SAFETY EVALUATION BY THE OFFICE OF NUCLEAR REACTOR REGULATION

SUPPORTING AMENDMENT NO. 58 TO FACILITY OPERATING LICENSE NO. NPF-14

SUSQUEHANNA STEAM ELECTRIC STATION, UNIT 1

AMENDMENT TO FACILITY OPERATING LICENSE

MAXIMUM AVERAGE PLANAR LINEAR HEAT
 GENERATION RATE (MAPLHGR) VERSUS
 AVERAGE BUNDLE EXPOSURE
 EXXON 8X8 FUEL
 FIGURE 3.2.1-2

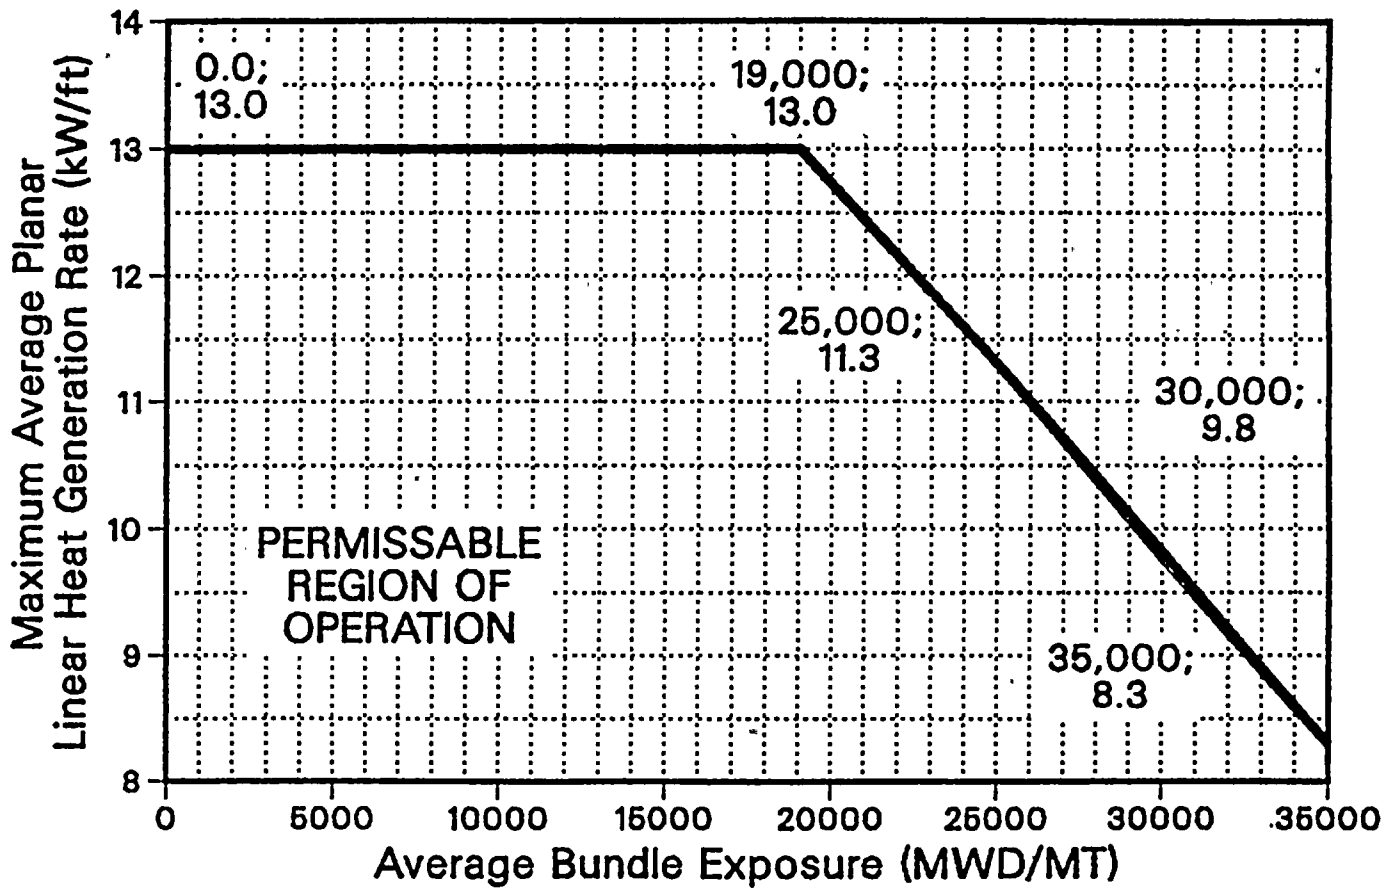
- (1) 3.1.2, Action b.: This is an administrative change to correct an error. It is an acceptable change.
- (2) 3/4.2.1 and related figures: This change removes the figure for MAPLHGR vs exposure for 1.8 percent enriched GE fuel (not used in Cycle 3) and provides a (similar) figure for Exxon 8x8 fuel for both XN-1 and

XN-2 type fuel. The Exxon figure for XN-2 fuel is the same as that used for XN-1 fuel up to 25 GWD/MTU, because the LOCA analyses for XN-2 fuel is calculated to fall within the same limits. Beyond 25 GWD/MTU the curve is more restrictive than required by the LOCA analyses in order to maintain the power history assumed in the approved mechanical design analysis. These changes are acceptable.

LINEAR HEAT GENERATION RATE (LHGR) LIMIT
 VERSUS AVERAGE PLANAR EXPOSURE
 EXXON 8X8 FUEL
 FIGURE 3.2.4.2-1

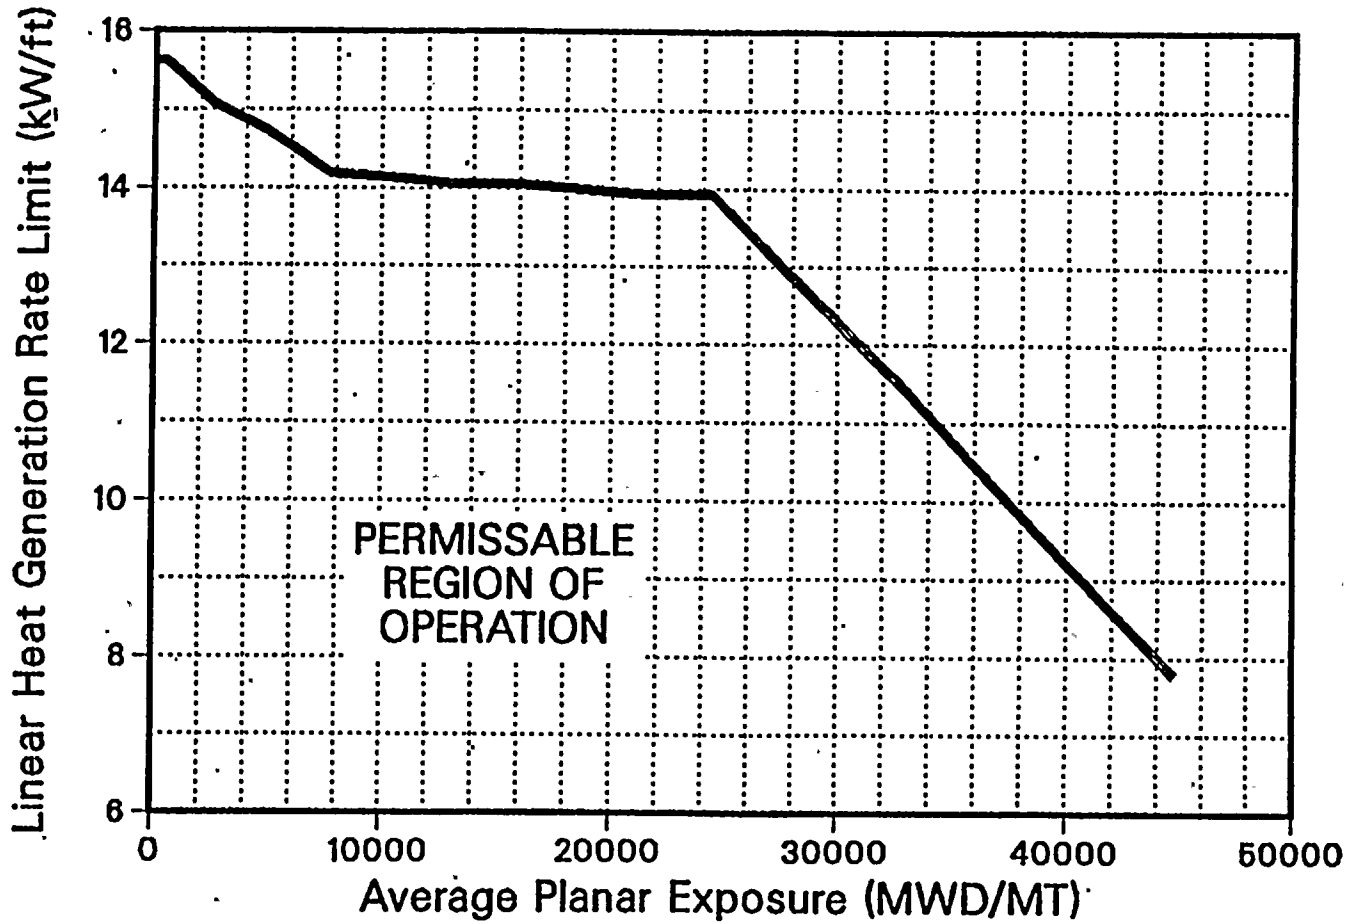
- (5) 3/4.2.4.1 and .2 and Figure 3.2.4.2-1: These changes provide a LHGR limit for Exxon fuel in addition to the existing GE fuel limit. The Exxon limit is a function of exposure and provides information to find the value of T in specification 3.2.2. It is to be noted that the correct figure is provided in Reference 4. Reference 4 contains only a small correction over a limited burnup range.
